SUPPLEMENT TO THE APPLICATION FOR SITE CERTIFICATE FOR THE KLONDIKE III WIND PROJECT

Klondike III Wind Power Project

Response to First Request for Additional Information (RAI) – Dated July 8, 2005

Response to Second Request for Additional Information (RAI) - September 15, 2005

Klondike III Wind Project
Figure K-1
Land Use

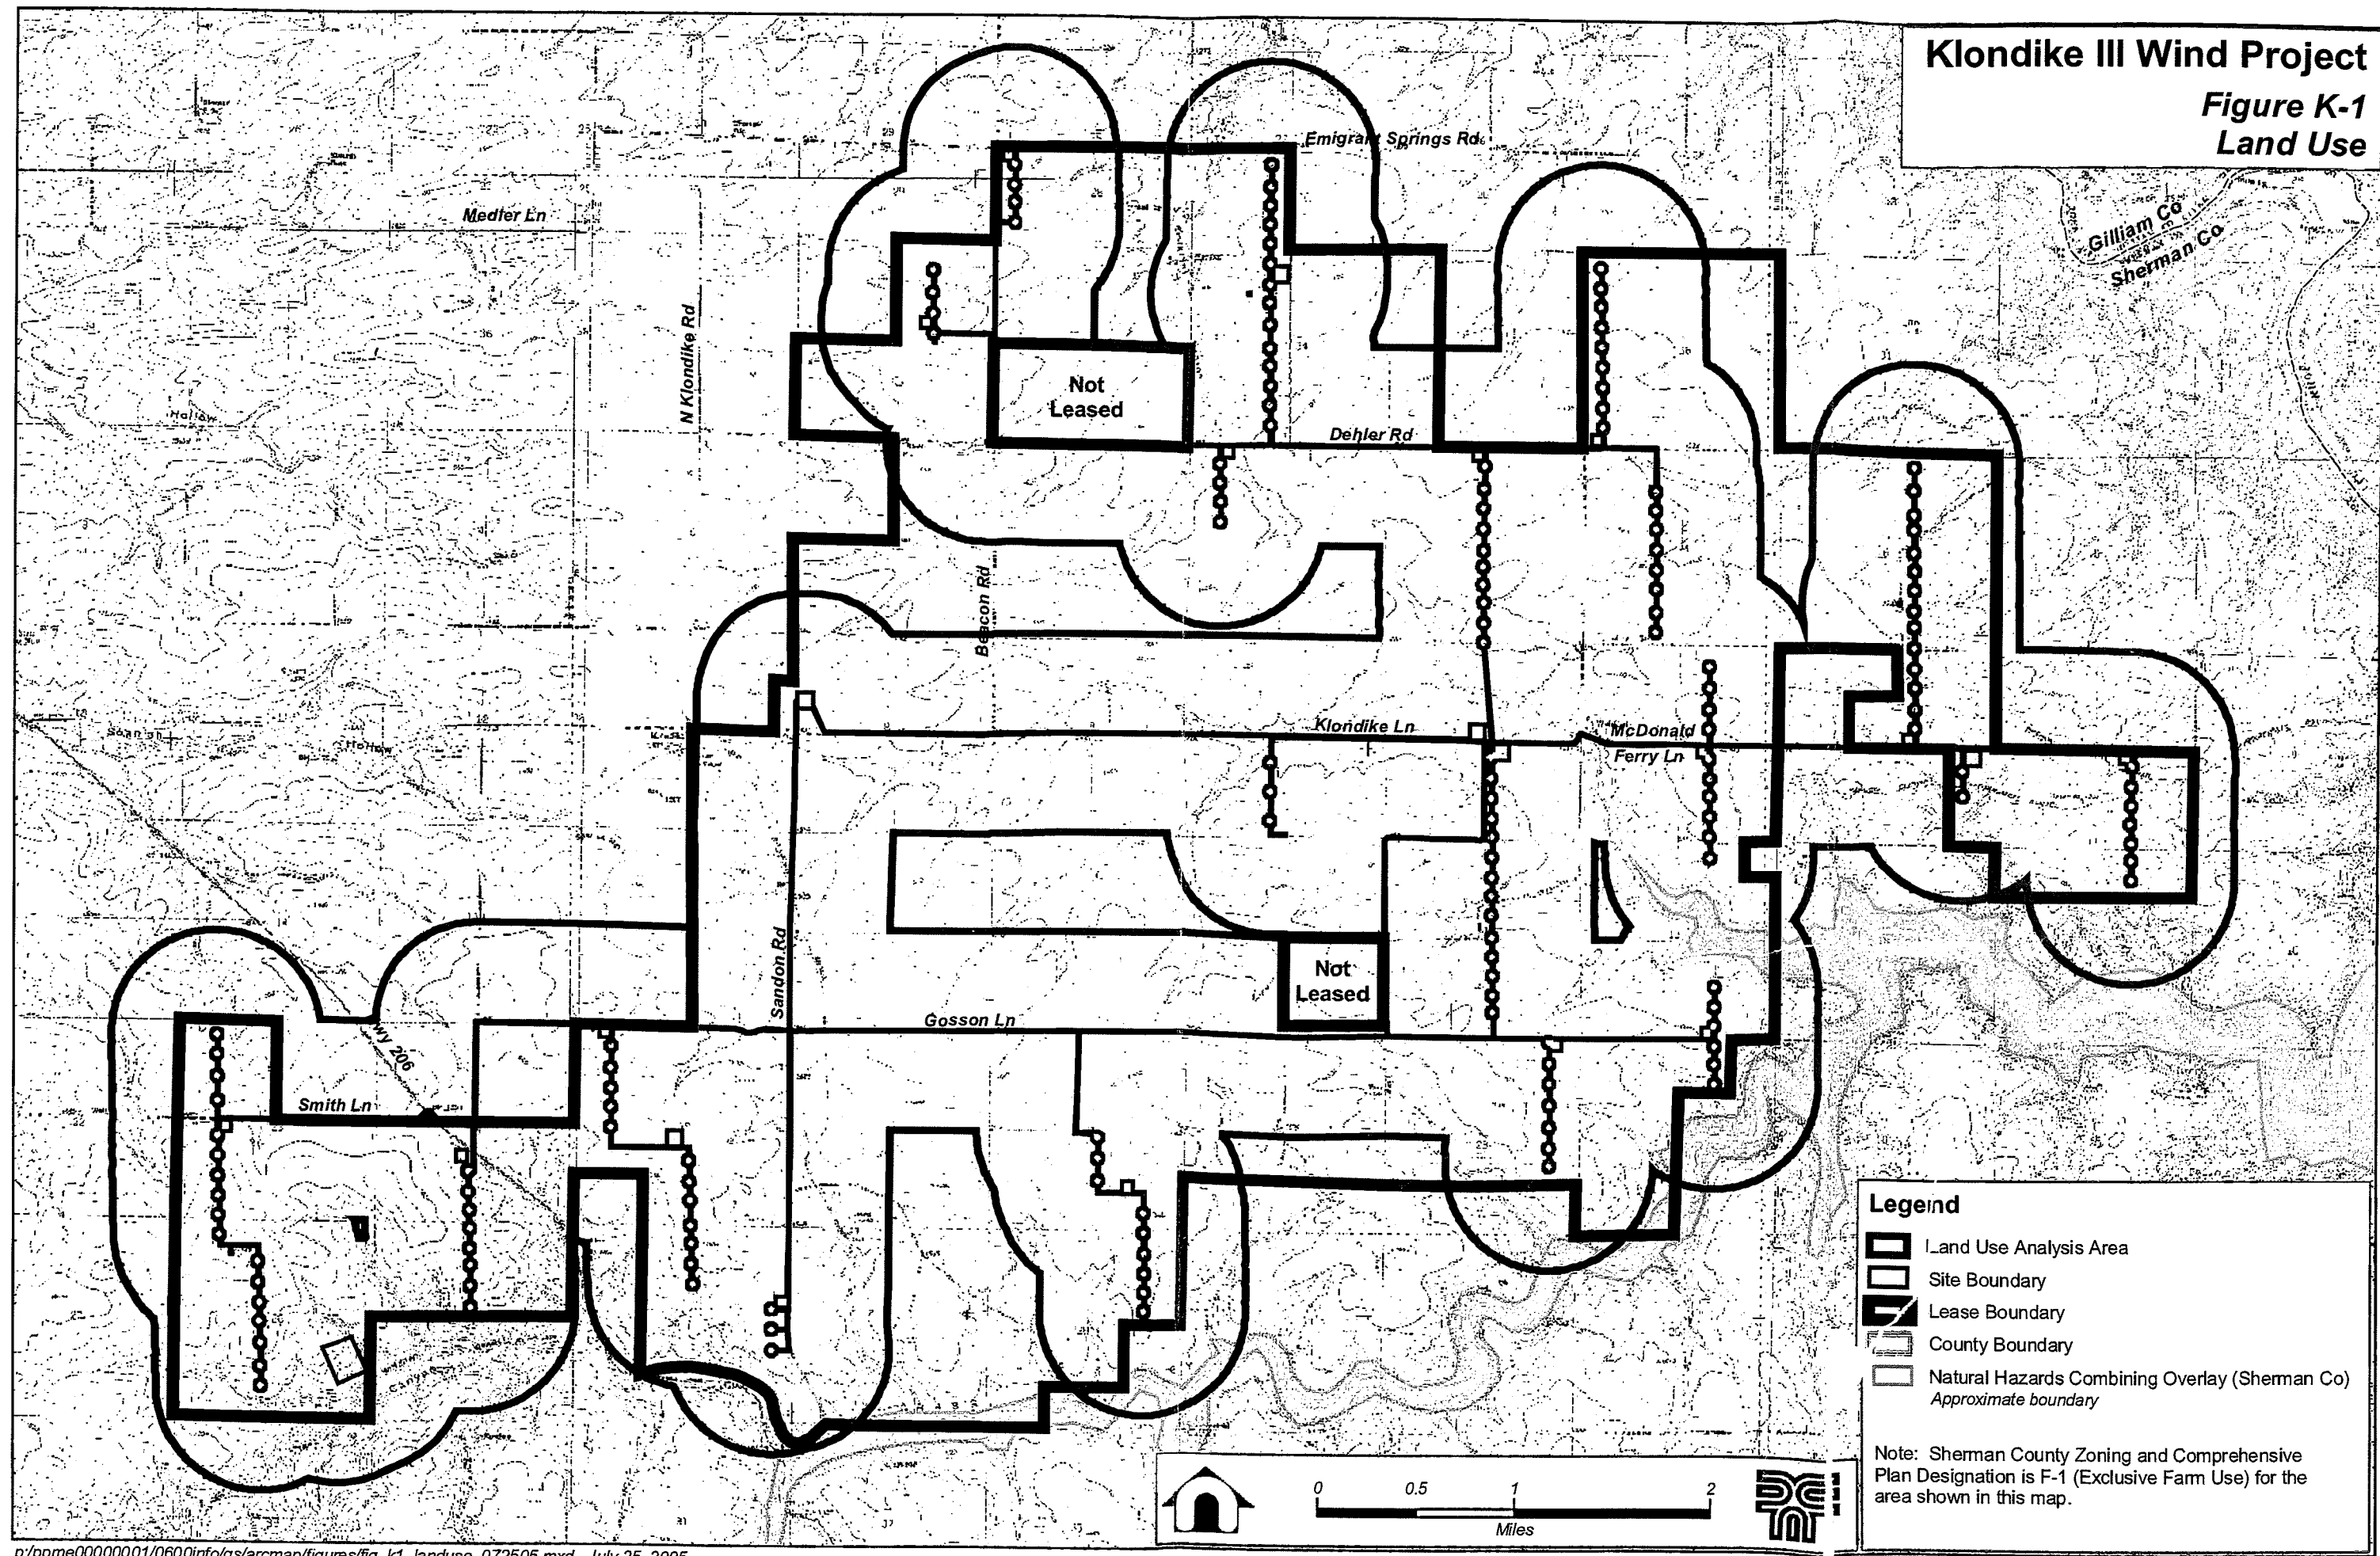
Exhibit K - Land Use		
K1	K-2	<p>The application says on page K-2 that Figure K-1 shows “Comprehensive Plan designations,” County zones and areas of temporary disturbance, but Figure K-1 does not show this information. Please provide a map as described in OAR 345-021-0010(1)(k)(A).</p> <p>Response: A revised map has been provided and is attached in RAI Appendix K.</p>
K2	K-4	<p>Would there need to be one or more turn-around areas on each turbine string to allow room for large construction vehicles to maneuver? Will the turn-around areas be included within the 19 temporary staging areas? If not, will the turn-around areas be areas of permanent disturbance, or would they all be restored upon completion of construction?</p> <p>Response: A temporary turnaround for the crane at the end of each string will be required during construction; all of these areas will be restored as described in Exhibit I; lands will be returned to cropped areas or re-seeded to stabilize soils.</p>
